## Product Change Notification / CENO-16DNCZ633

CCB 5332 Initial Notice: Qualification of palladium coated copper with gold flash (CuPdAu) bond wire material and 104x150 mils lead-frame paddle size for selected PIC16F153xx, PIC16F183xx, PIC16F184xx, PIC16LF15xx and PIC16LF18xx device families available in 14L SOIC (.150in) package.

**CCB 5332**  
**Pre and Post Change Summary**  
**PCN #: CENO-16DNCZ633**

# LEAD FRAME COMPARISON

## Pre Change

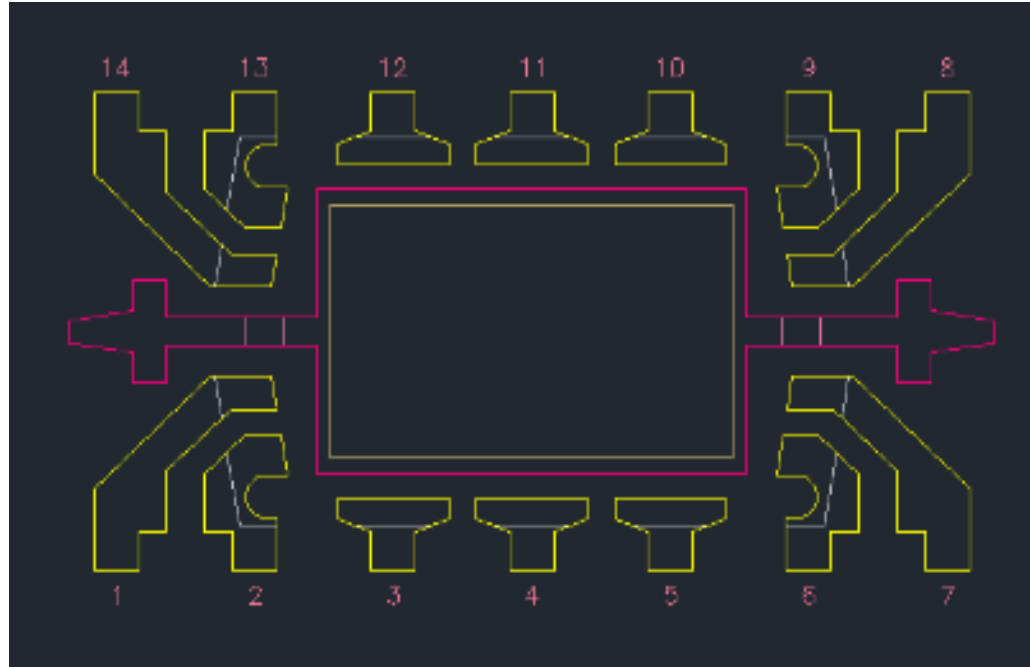
Lead Frame Material	A194
Paddle size	95 x 155 mils
DAP Surface Prep	Ag
Wire Material	Au

## Post Change

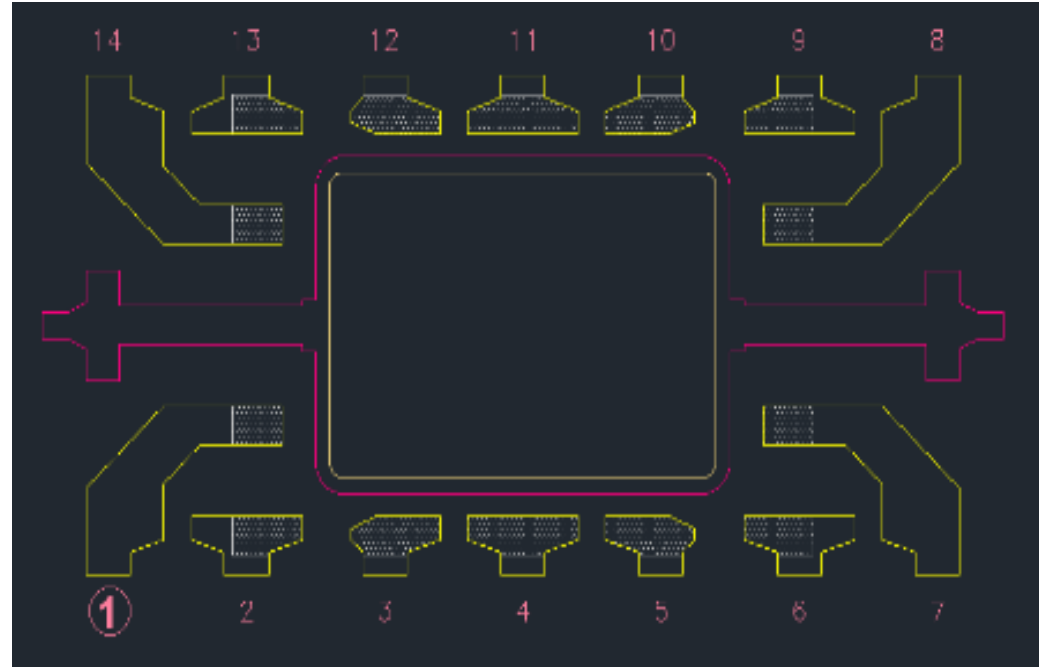
Lead Frame Material	A194
Paddle size	104 x 150 mils
DAP Surface Prep	Bare Cu
Wire Material	CuPdAu
